### **EQB Staff Summary of Selected Scoping Comments**

The following list is an EQB staff summary of major public comments on the scope of the environmental impact statement for the Xcel Energy 345/115-kV high-voltage transmission line in Southwest Minnesota:

### High-Voltage Transmission Line and Substation Site Screening Criteria

### Rejected Route Segments

Figure 4

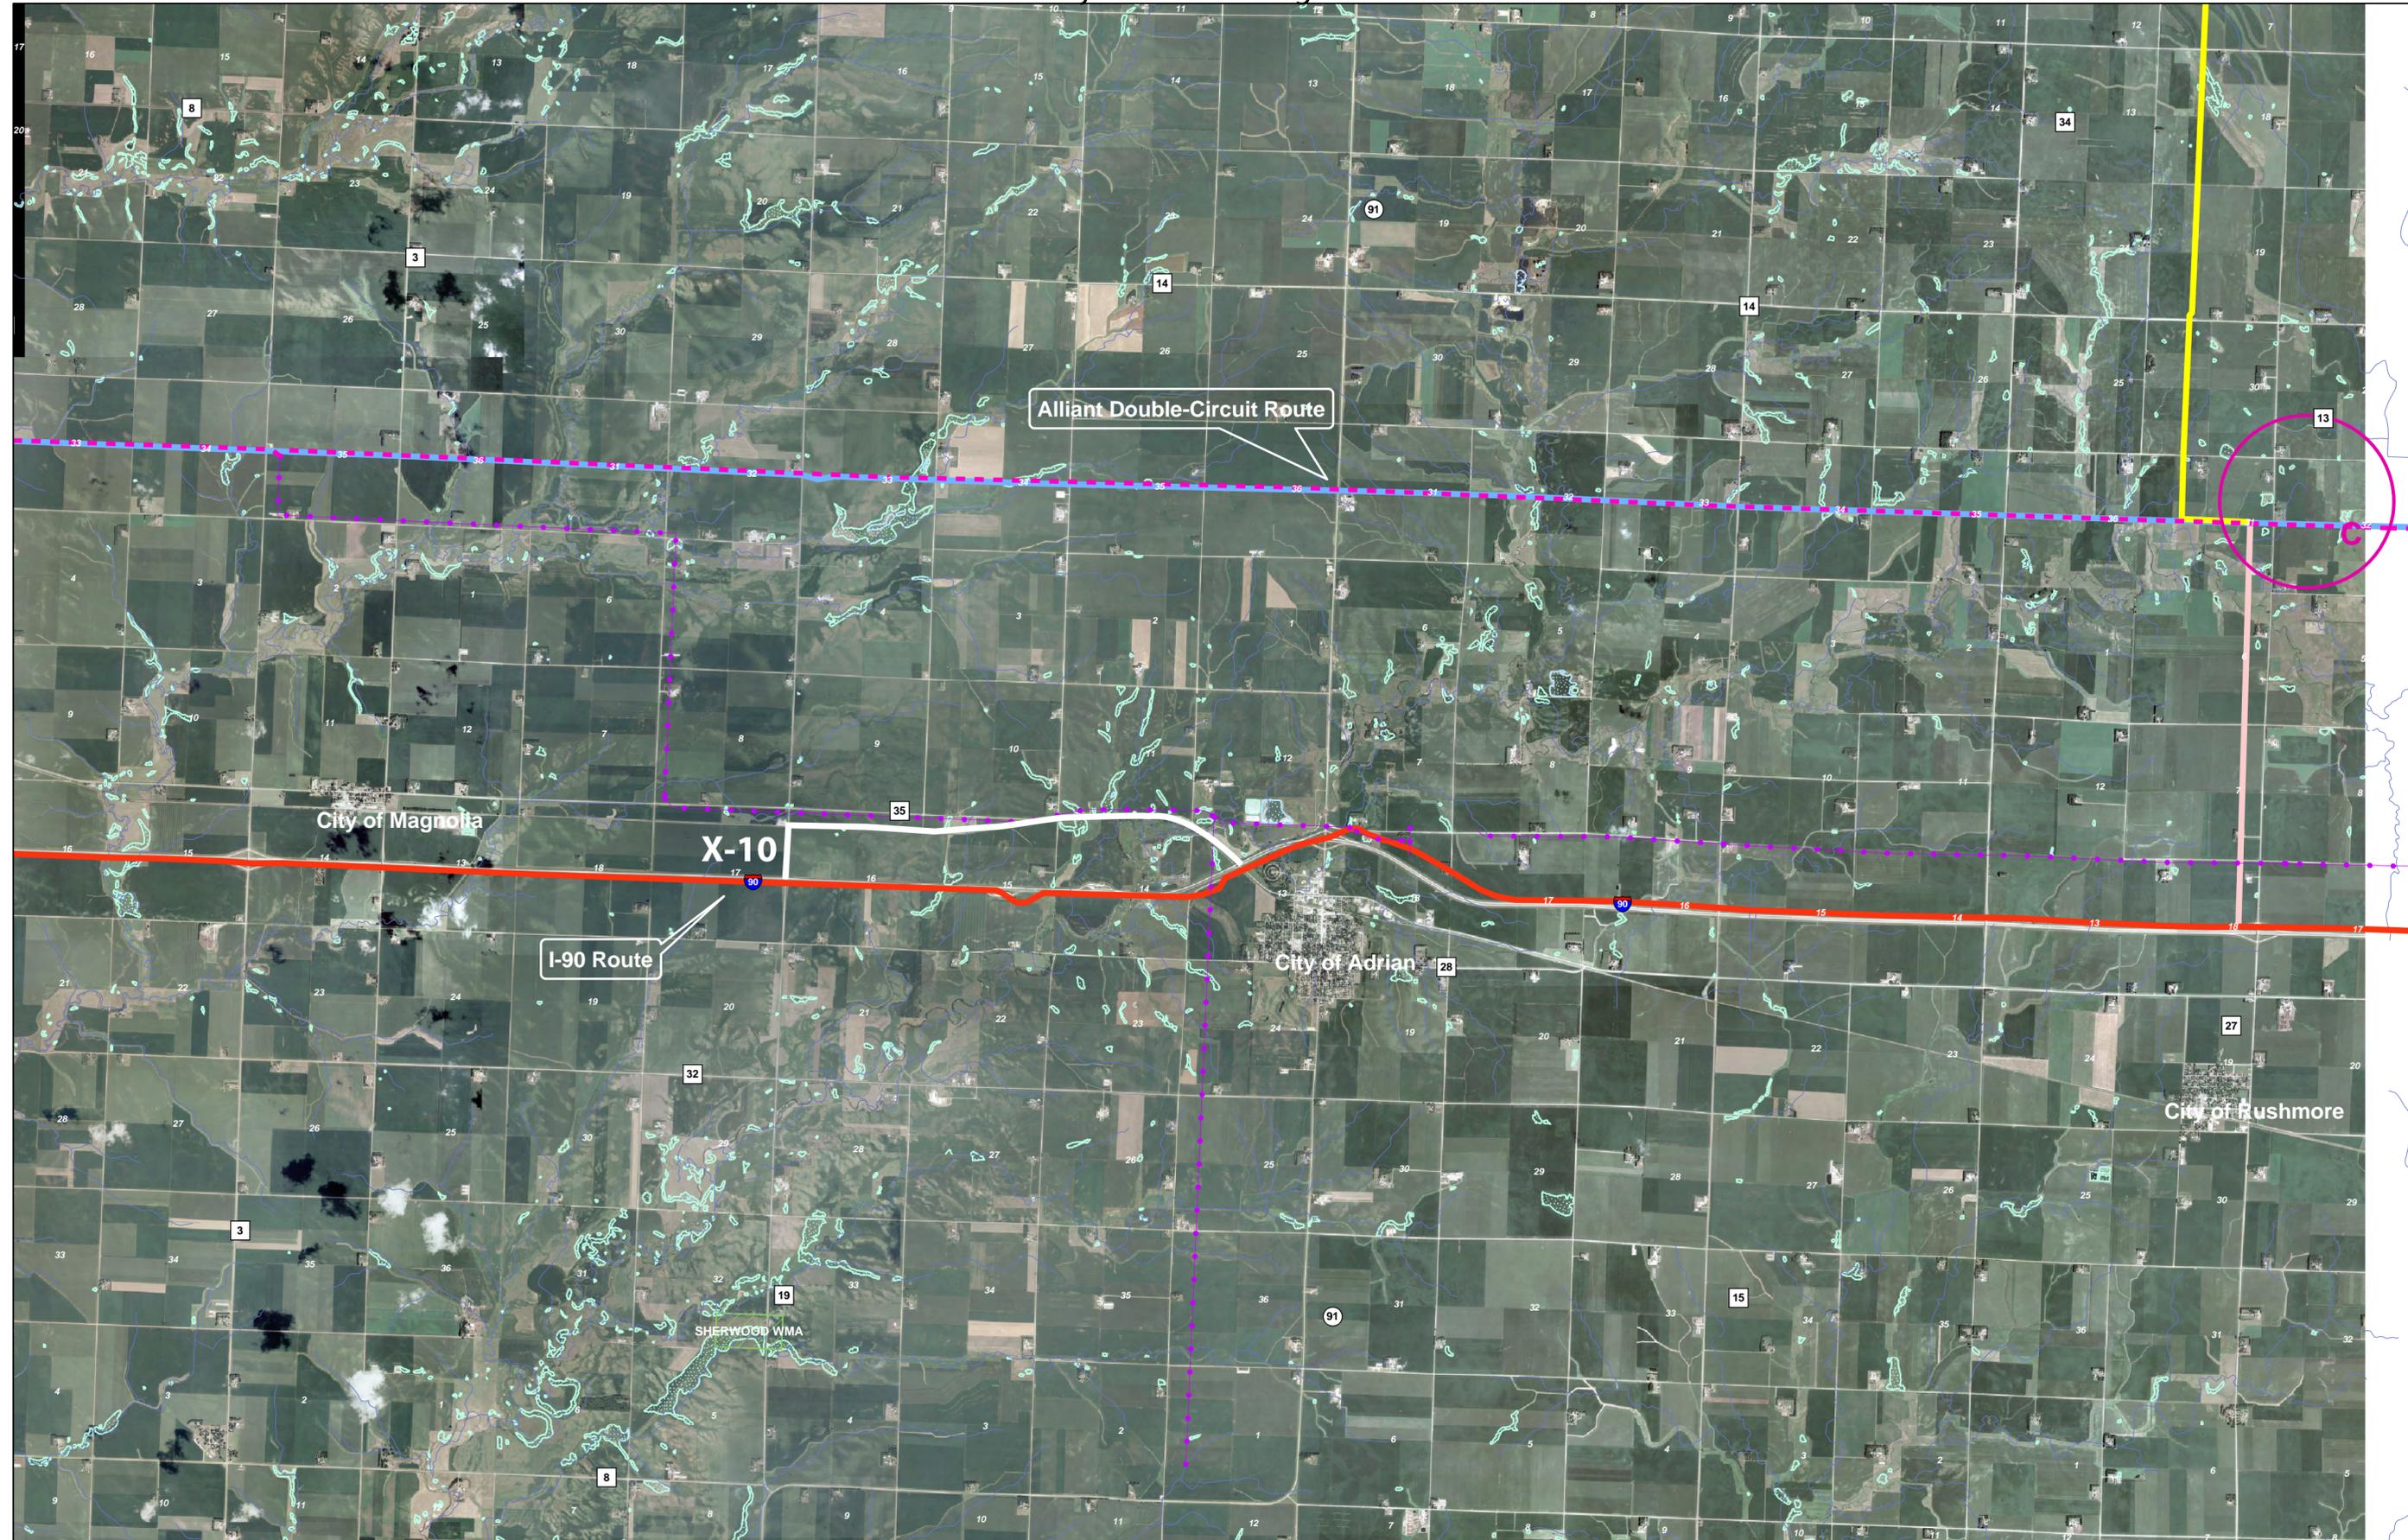
X10. (Figure 4) This suggested route-segment follows a railroad right-of-way just west of the City of Adrian, instead of I-90. It was rejected for several reasons. First, there are wetlands and fens along the railroad tracks. Second, it requires crossing the Kanaranzi River. Third, there is a cluster of nearby homes, low ground generally, and there is a fiber optic line in the area. The EIS, however, will evaluate whether the existing 69-kV line in this area can be consolidated onto the same poles as the new 345-kV line, should the I-90 route be selected in this area.
